**CCB 7907**  
**Pre and Post Change Summary**  
**PCN #: CENO-01UVKE616**

# Lead Frame Comparison

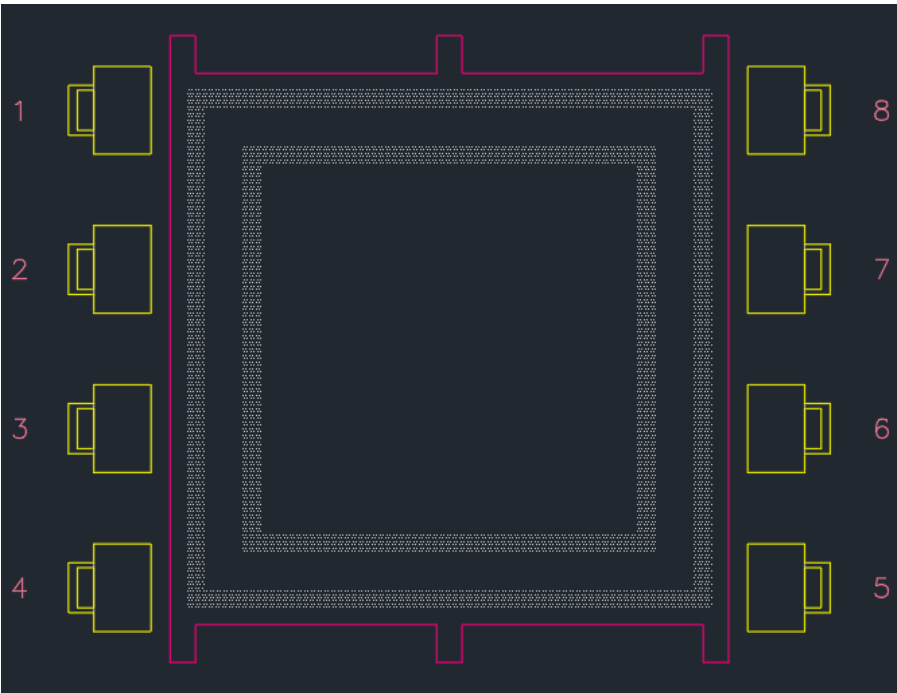
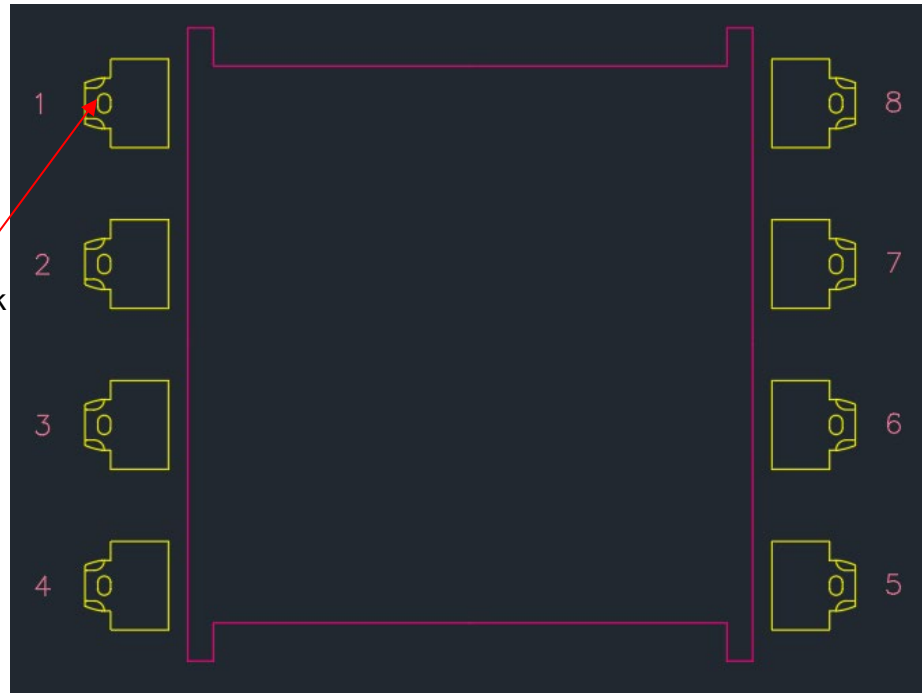
<b>Lead-Frame Material</b>	EFTEC-64T	<b>Lead-Frame Material</b>	A194
<b>Lead-Lock</b>	Yes (Dimple)	<b>Lead-Lock</b>	Yes (Locking Hole)
<b>DAP Surface Prep</b>	Ag ring	<b>DAP Surface Prep</b>	Bare Cu

Note 2: Mold compound materials fills the leadlock hole, which provides improved protection against moisture penetration along the edge of the leads (pins) of the package.
